Flat A 15 Well Walk 2017/3214/P

I am commenting on aspects of this application as they relate to trees and to groundwater as Tree Officer of the Heath & Hampstead Society, and a member of its Planning sub-committee.

Planning Ref: 2016/6491/P

Description: Rear Extension at basement and ground floor.

1866 OS map showing large pond downstream of 15 Well Walk

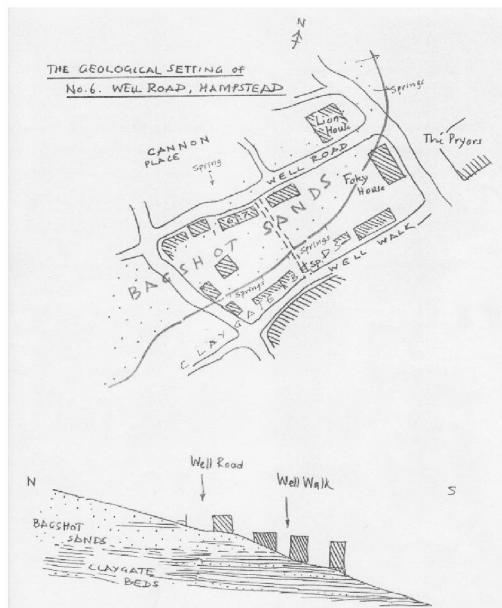
The 1761 map and 1866 OS map of the area show the large pond where Gainsborough Gardens now are, originally fed by a spring originating in Well Road, later directed via a conduit running below Wells passage (that also fed the Chalybeate well, also known as a spring). Well Road and Well Walk in parts are well known to be on a surface spring line along the boundary of the Bagshot Sands and the Claygate Beds (to see the water flow at this boundary look at the video of the well uphill from here on: <http://www.heathandhampstead.org.uk/planning>) with some of this groundwater passing on downhill within the silt and sand partings of the overlying Head and the Claygate Beds. The Bagshot-Claygate beds boundary drawn on the British Geological Survey map is dashed, indicating that's its exact position – as drawn on the BGS map – is variable and not confirmed. This is supported by the borehole reported near here which shows Bagshot sand present for 1.5 m.

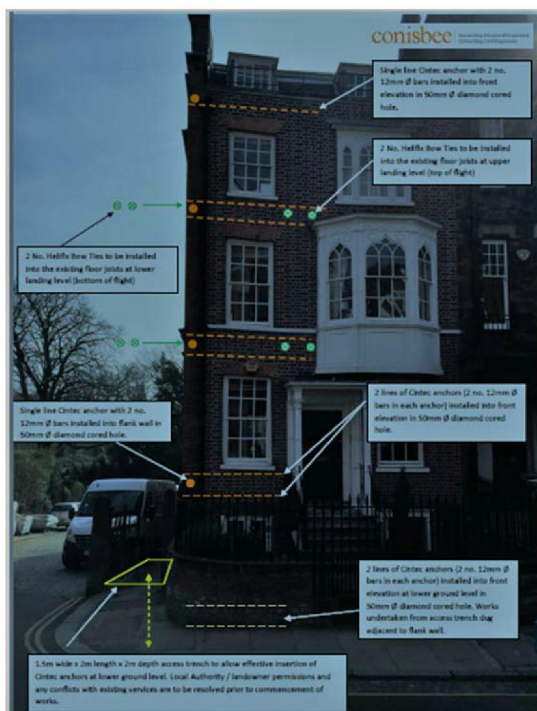
A Borehole was dug on 6th February 2013 though the results were not submitted then. They have now been discovered at the back of the Structural Engineer's Assessment in the 2017/3214/P application. While December 2012 had been a wet month, total rainfall for January 2013 was 47.0mm (85% of 30-year average rainfall for

January) and in February only 9.2mm had fallen up to Feb 6th, 7mm of this on Feb 1st. Hence the borehole was dug at a dry time and no continuous monitoring of groundwater levels across storm surges was performed as now required by the Local Plan Policy A5 Basements commensurate with this hydrogeologically highly sensitive area.

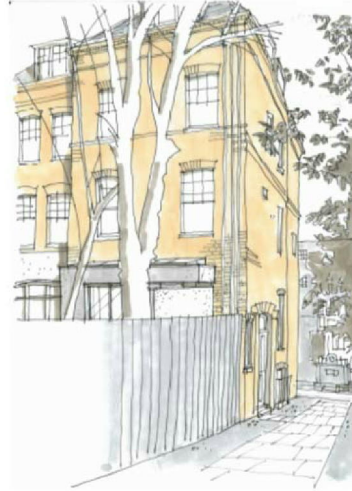
The arboriculturalist's survey was performed on 9th August 2012. This survey report is now 4 years out of date, so considering the extent of encroachment then by the proposed work into the trees' Root Protection Zones, the trees must be re-surveyed to ensure this encroachment is still within the spirit of B.S.5837 (2012). The arboriculturalist states that he has assumed that all construction work will be carried out by hand... within the footprint of the proposed construction. This is not confirmed by a CMP or BCP.

The report also states that no detailed tree examinations were performed. In view of the bats that frequent this area I would expect to see confirmation that there are no bat roosts, particularly in the lime tree.
